Appendix C - Agency Approval Documents

SHEET 1 OF 1
 BATTERY LANE URBAN PARK
 BETHESDA, MARYLAND
 7TH ELECTION DISTRICT
 NATURALRESOURCE INVENTORY
 AND
 FOREST STAND DELINEATION

Re: Stormwater Management **CONCEPT** Request
for Battery Lane Urban Park
SM File #: 235790
Tract Size/Zone: 1.95 Ac./R-200
Total Concept Area: 1.95 Ac.
Parcel(s): E
Watershed: Lower Rock Creek

BATTERY LANE PARK FACILITY PLAN

Preliminary Design Option A

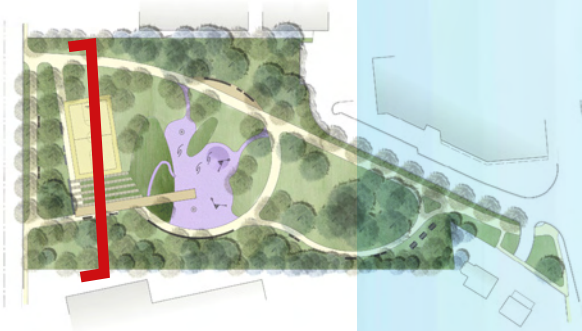
- d. Oculus recommends that above ground utilities be moved underground.
3. Oculus review of two initial design sketches.
 - a. Scheme A proposes a single primary path that curves through the park, flanked by special seating. The basketball court is shifted to the west edge of the park, a new, larger playground area is located near the east edge of the park, and a rain garden is located along the primary path near the north east entrance to the park. The changed basketball court location and the removal of the tennis court allows for large grassy areas for passive and un-programmed active recreation.

4. Comments and discussion of design sketches
 - Show property line more clearly on graphics.
 - Keep in mind maintenance access; the maintenance crew wants truck access to all parts of the park-10' drive lane.

- Could basketball court be moved further from residences? Noise could be a problem for neighbors.
 - Some rain gardens have not been well-maintained in Montgomery County; Consider maintenance when proposing rain garden.

- The single arching path in Scheme A, with less direct route through the park is a nice, simple scheme.
- General approval of long, linear seating elements in scheme A.
- What is the memorable signature element in the design?
- The custom seating element could be the artistic, stand-out element that makes Battery Lane Park memorable.
